SUBJECT: Forwards proprietary response to request for addl info re Unit 1 core shroud repair & Rev 0 to 383HA718, "Thermal Cycle, Reactor Vessel & Nozzle - Description, Bases & Assumptions." Rev 0 to 383HA718 withheld (ref 10CFR2.790).

Subject: *Response to Request for Additional Information Regarding the Nine Mile Point Unit 1 Core Shroud Repair (TAC No. M90102)*

Request for Additional Information Regarding Core Shroud Repair Nine Mile Point Unit 1

Figure 1. Lateral Shear Force vs. Elevation for Nine Mile Point Unit 1 Blowdown Analysis

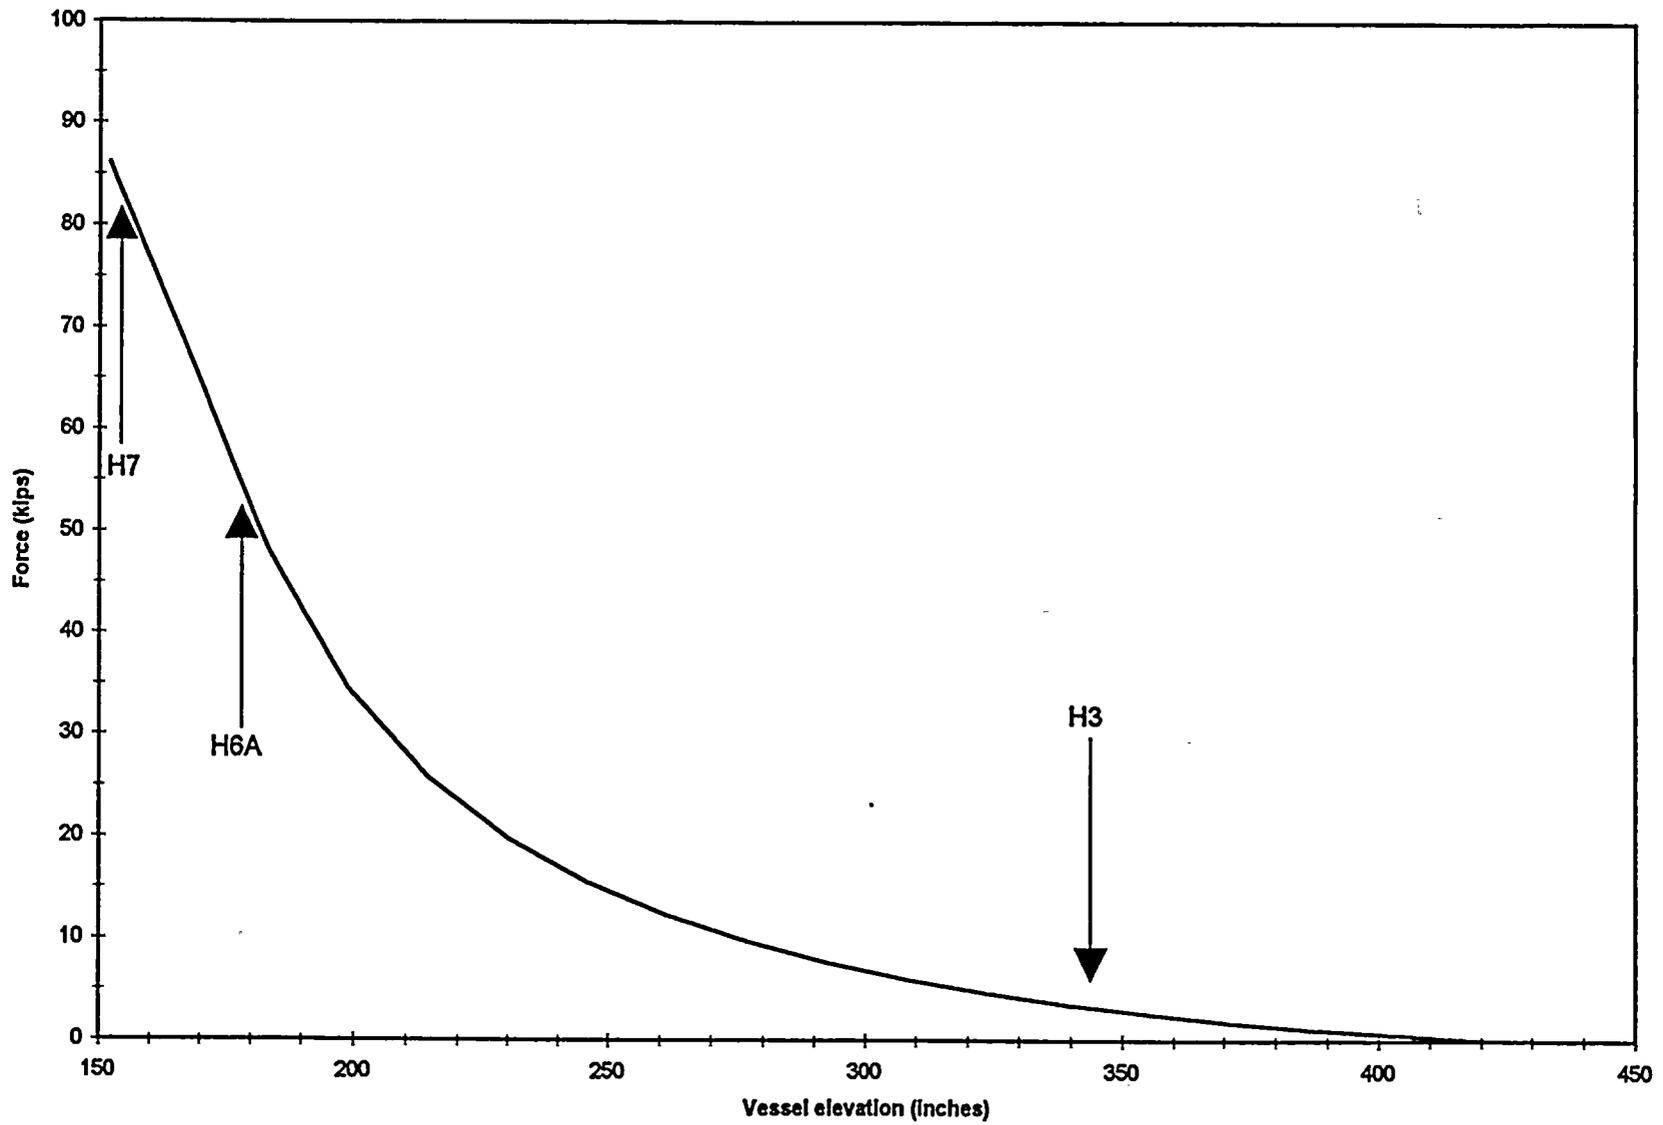
Provide a copy of Reference 7 (letter to Roy Corieri and George Inch from J. A. Villalta and A. Mahadevan, Subject: Displacement of the Nine Mile Unit 1 Shroud due to DBE and Recirculation Line Break, dated September 26, 1994) which discusses the asymmetric loads during a recirculation line break.

The referenced memo (Attachment 4) contains the asymmetric loads on the shroud resulting from a recirculation line break. The limiting stabilizer load is its reaction load against the overturning moment. Assuming weld failures below the core support, the lower spring contact provides the pivot point about which the shroud rotates. The moment at the pivot location is 4500 kip-inches. Weld failures above this location move the pivot point up, and the reaction moment is less.

The calculated lateral force above the H7 weld is shown in Figure 1. The lateral force on the shroud assembly above H7 is 86 kips. The corresponding blowdown moment, taken about H7, is 4700 kip-inches (see Figure 2). This moment is much smaller than the restoring moment calculated in the seismic assessment of the shroud (3905 kip-feet). Thus, tipping due to a lateral blowdown load is not deemed possible and impairment of control rod insertion during scram is unlikely.

NINE MILE POINT, CORE SPRAY PIPING
 ANGLES 25. 115. 90.

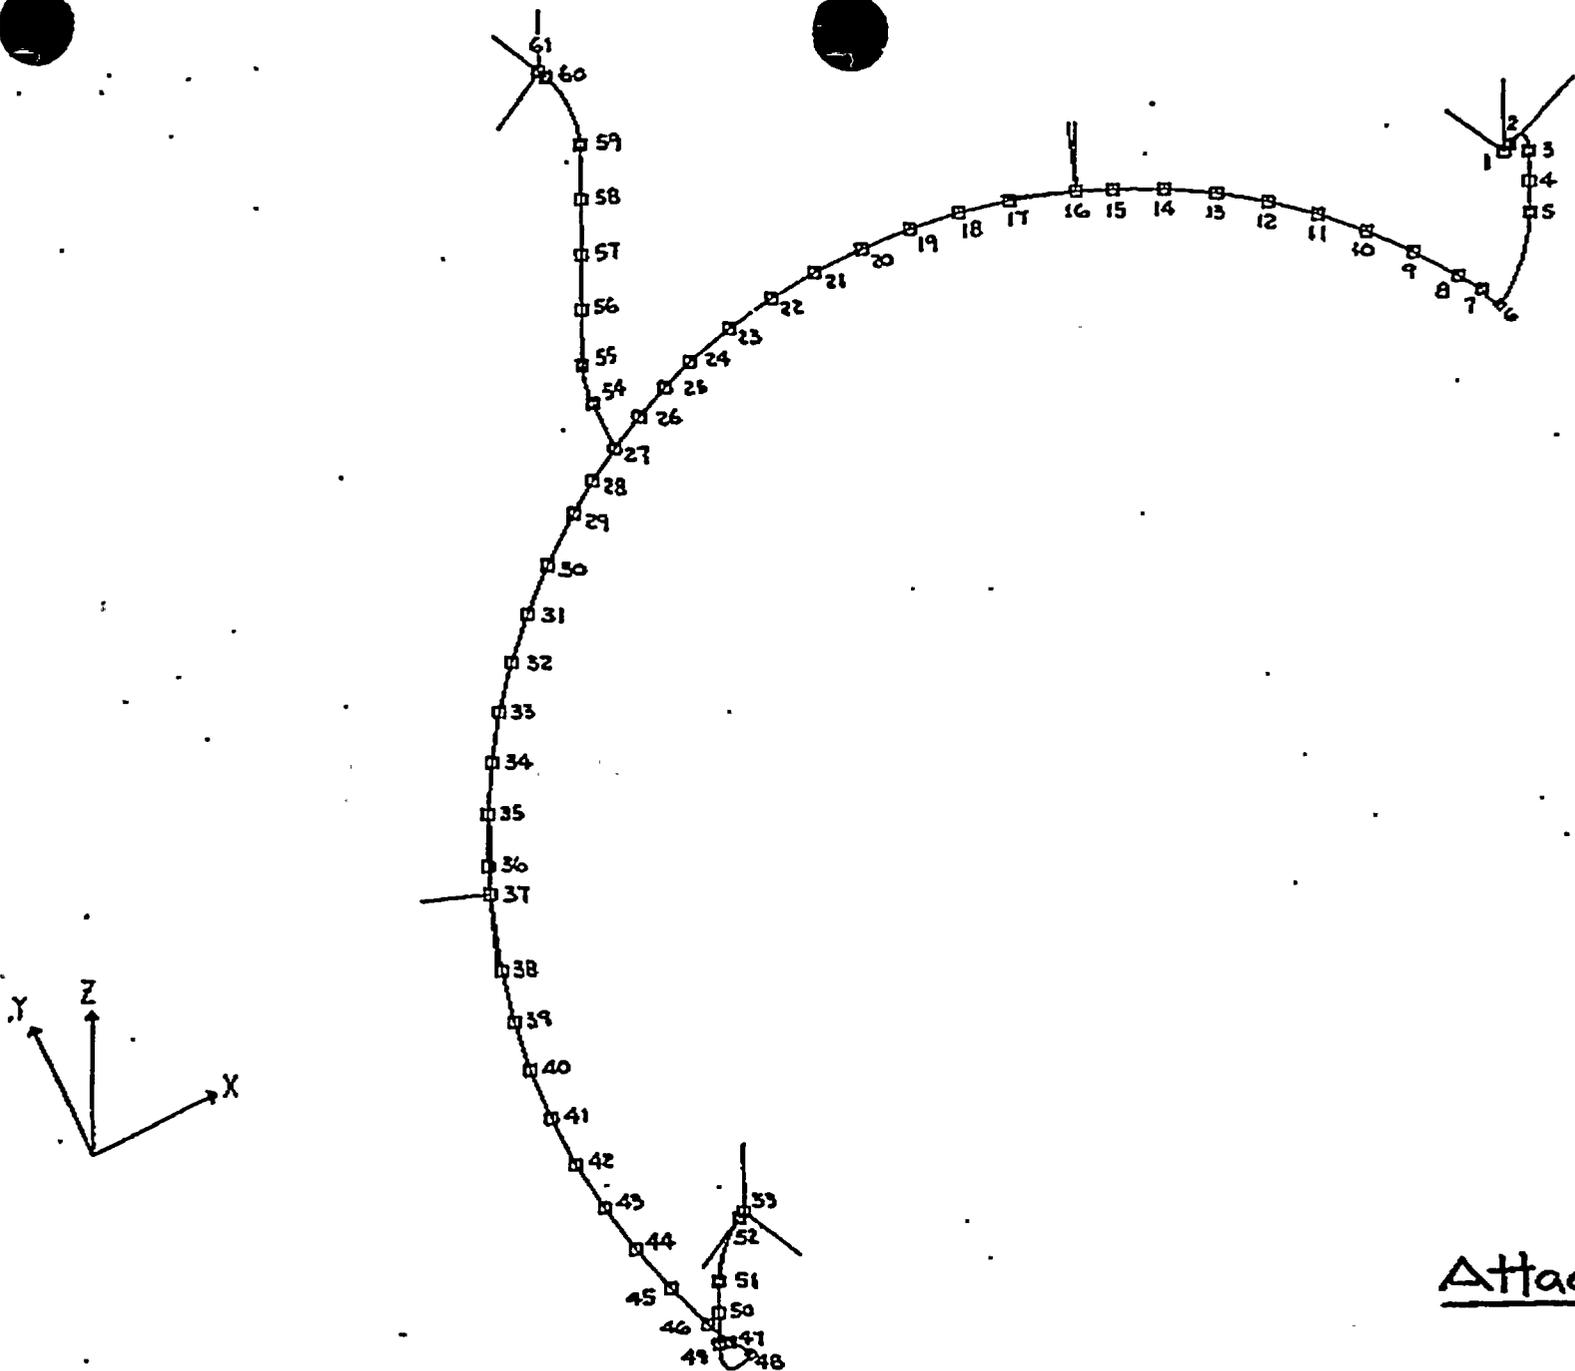
Provide the analysis performed to demonstrate the integrity of the core spray piping when subjected to shroud displacements of 0.904 inches and 0.61 inches in the horizontal and vertical directions, respectively.

The core spray piping analysis is attached (Attachment 6). The core spray piping was modeled and analyzed with the SAP finite element analysis program. The analysis includes a 0.904 inch horizontal shroud movement and a 0.61 inch vertical shroud movement. The maximum strain was calculated at 1% which occurs at the elbow in the riser section of the piping. A 2.5% strain is permissible to prevent material cold-working. Although the 1% strain may result in local plastic deformation, it will not affect the performance of the core spray piping.

The table below is a summary of the results showing the maximum strain in the piping and nozzles and the bracket loads.
